1990 Corvette: Service Bulletin: L98 and LT5: Revised Air Conditioning Control Circuit Diagnosis

Subject: REVISED AIR CONDITIONING CONTROL CIRCUIT DIAGNOSIS

Model and Year: 1990 CORVETTE WITH 5.7L L98 AND LT5 ENGINES

Bulletin Number: 90-400-6E

CHART C-10
 (Page 1 of 2)
A/C CLUTCH CIRCUIT
DIAGNOSIS
5.7L (VIN 8) & 5.7L (VIN J)
"Y" CARLINE (PORT)

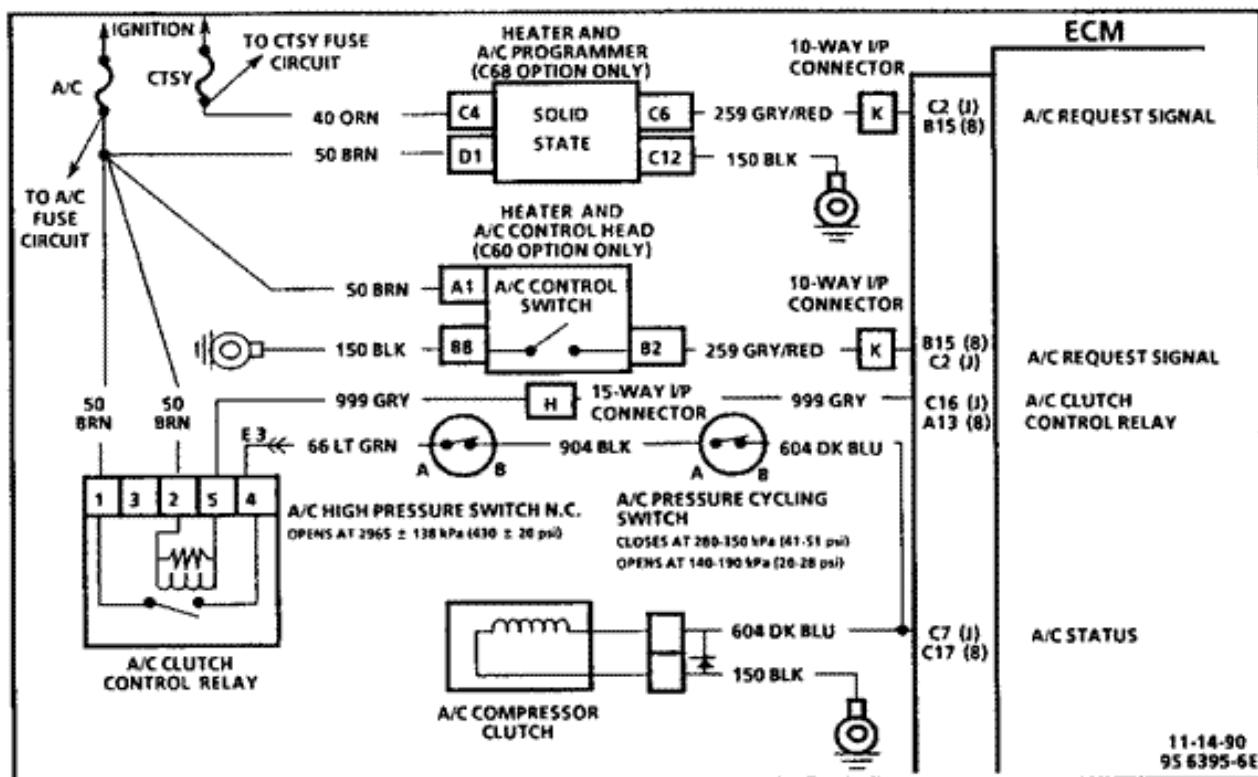
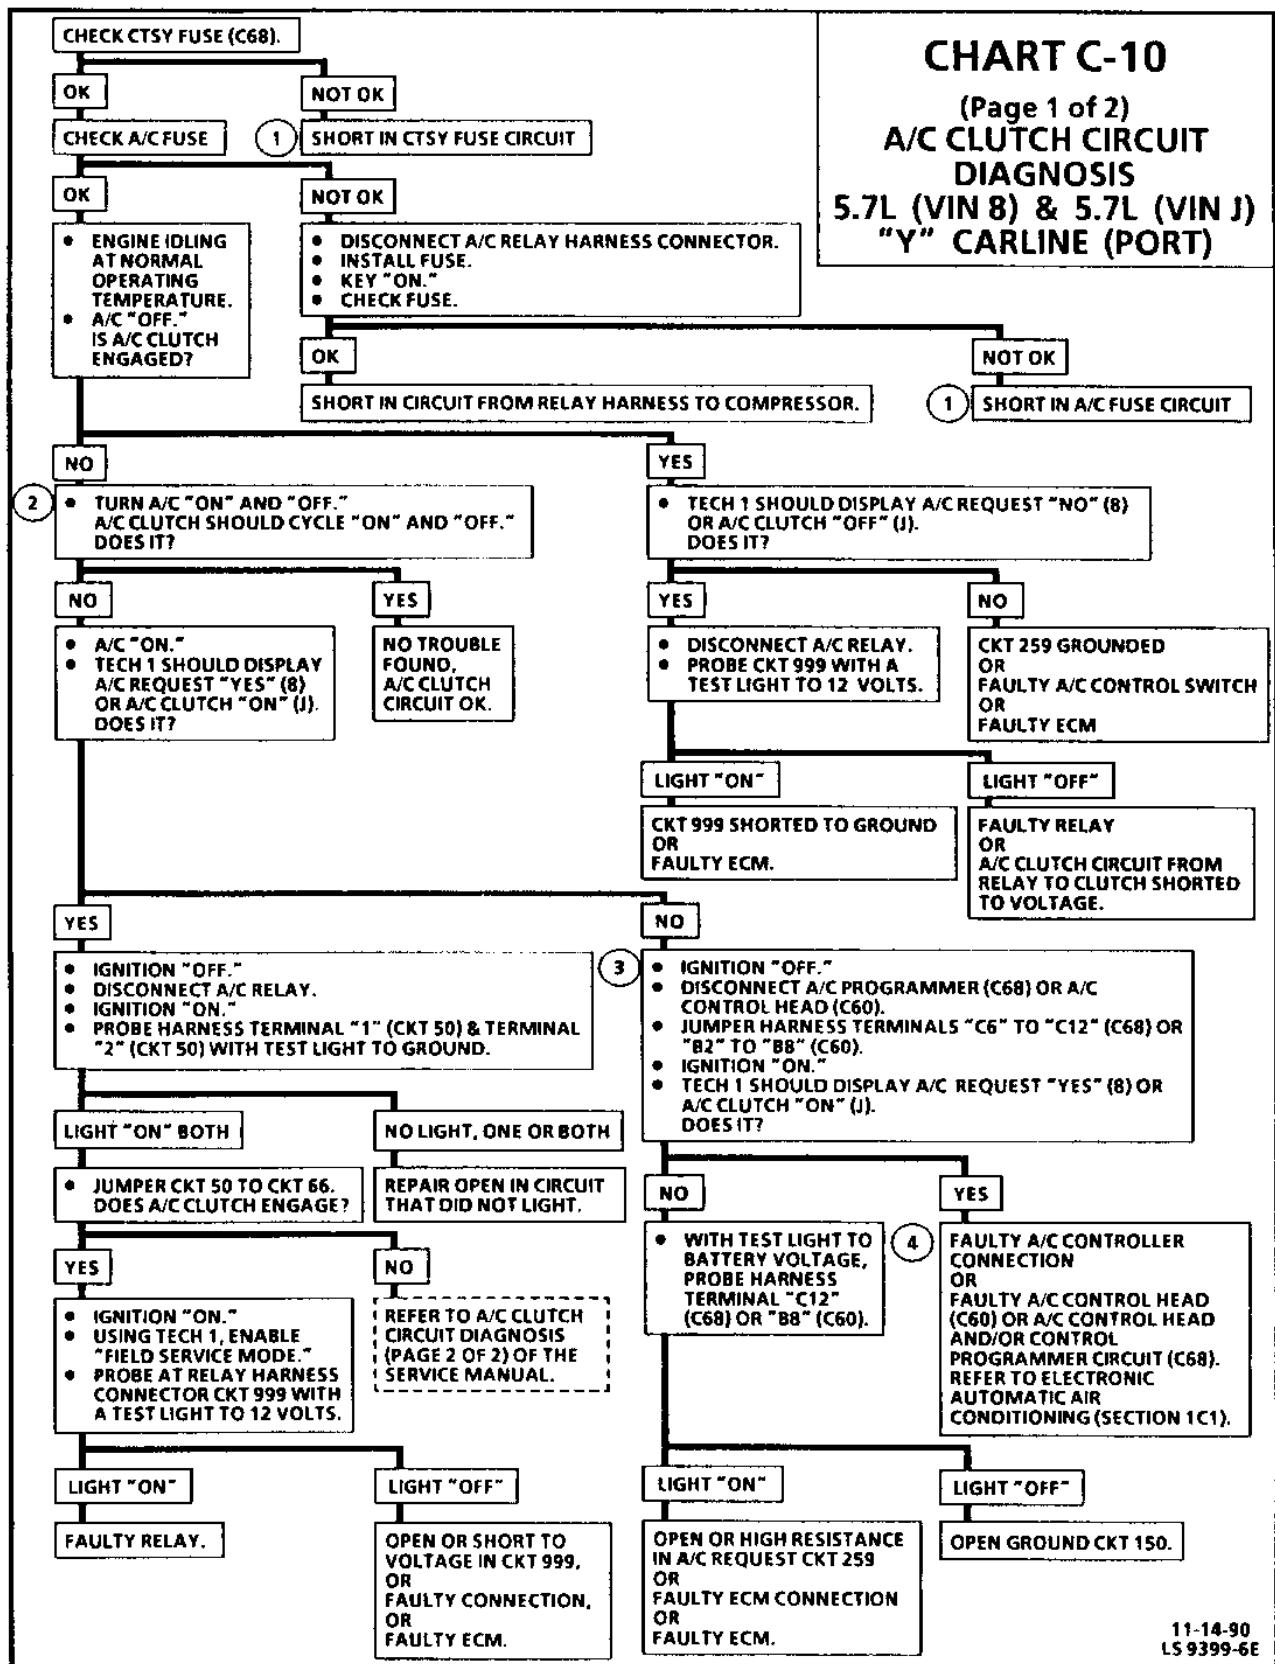
The following information updates the A/C clutch circuit diagnostic chart and facing page information found on pages 6E3-C10-4 and 6E3-C10-5 in Section 6E3 "Driveability And Emissions" for the 1990 "Y" 5.7L L98 (VIN 8) and LT5 (VIN J) Corvette Service Manual.

The A/C clutch control relay is ECM controlled to delay A/C clutch engagement after

the A/C is turned "ON." This allows the ECM to adjust engine rpm before the A/C clutch engages.

The ECM will engage the A/C clutch any time A/C has been requested unless any of the following conditions exist.

- o High coolant temperature.
- o Wide open throttle.
- o High oil temperature.
- o Sustained high vehicle speeds (LT5).
- o High engine rpm.

The ECM can determine A/C request by sending a voltage signal to the A/C control head. When the A/C control switch is closed, the A/C request voltage signal is grounded. This is shown on the Tech 1 as A/C request "YES" (8) or A/C clutch "ON" (J).

When a request for A/C has been detected by the ECM, the ECM will ground the A/C clutch control relay drive circuit, the relay contacts will close and energize the compressor clutch portion of the circuit. If the system is properly charged, the circuit will be complete to the A/C compressor clutch.

When A/C request has been detected by the ECM, the cooling fan(s) will be turned "ON" unless vehicle speed is too high.

1. Refer to ELECTRICAL DIAGNOSIS (SECTION 8A) "FUSE BLOCK DETAILS" for fuse circuit power distribution.
2. Checks the ECM's ability to control the A/C clutch control relay.
3. Checks to determine if the ECM is capable of detecting the A/C request signal being grounded.
4. Before replacing C68 A/C control components," refer to ELECTRONIC AUTOMATIC AIR CONDITIONING (SECTION 1C1) for further A/C diagnostics.
